2020-44 (1ST READING): TO AMEND THE CLEMSON TRACT PUD TO ADD A SIGN MASTER PLAN FOR PARCEL 4 (COMMERCIAL TRACT.

<u>Purpose:</u> To ready the commercial development near Coventry Boulevard and Highway 17 for development.

ORDINANCE 2020-44	
1 2 3 4 5 6 7	CITY OF MYRTLE BEACH COUNTY OF HORRY STATE OF SOUTH CAROLINA	ORDINANCE TO AMEND THE CLEMSON TRACT PLANNED UNIT DEVELOPMENT (PUD), SECTION 10 - SIGNAGE REGULATIONS AND RELATED EXHIBITS TO ESTABLISH REGULATIONS SPECIFIC	
8		TO PARCEL 4 (COMMERCIAL TRACT)	
9 10	WHEREAS, the Clemson Tract Planned Unit Development (PUD) was established by		
11 12	Ordinance 2007-45; and		
13 14 15	WHEREAS, the Clemson Tract Planned Unit Development (PUD) was most recently amended via Ordinance 2018-064; and		
16 17 18	WHEREAS, the City Council sees fit to establish signage regulations for Parcel 4 in order to facilitate commercial development;		
19 20 21	THEREFORE, IT IS HEREBY ORDAINED that Section 10 of the Clemson Tract Planned Unit Development (PUD) is amended as follows:		
22 23	Section 1001. Signs.		
24 25 26	See attached signage master plan (Exhibit X.0) applicable for parcels 2, 3, 5, 6, and 7. See attached signage master plan (Exhibit X.3) appli

1 Exhibit X3

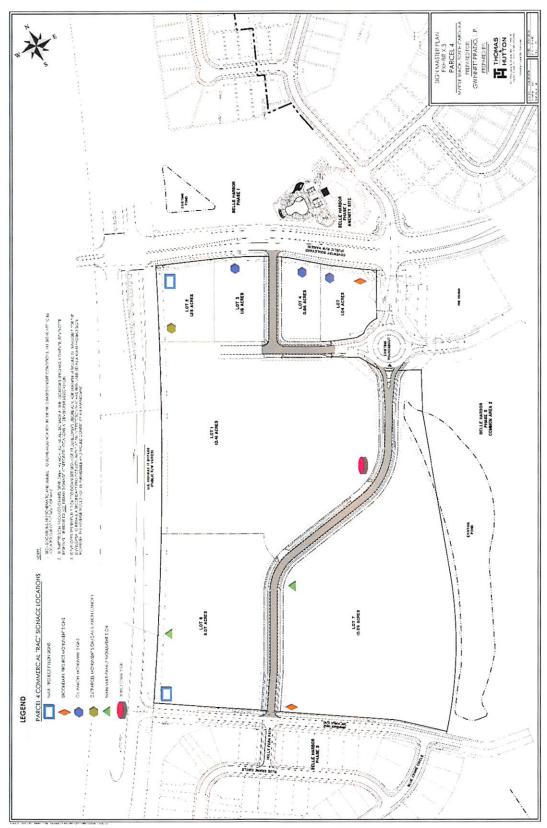
- Made it clear that the placement of the signs and the number of signs for Parcel 4 will be in accordance with the example signage location map.
- For all of the freestanding signs:
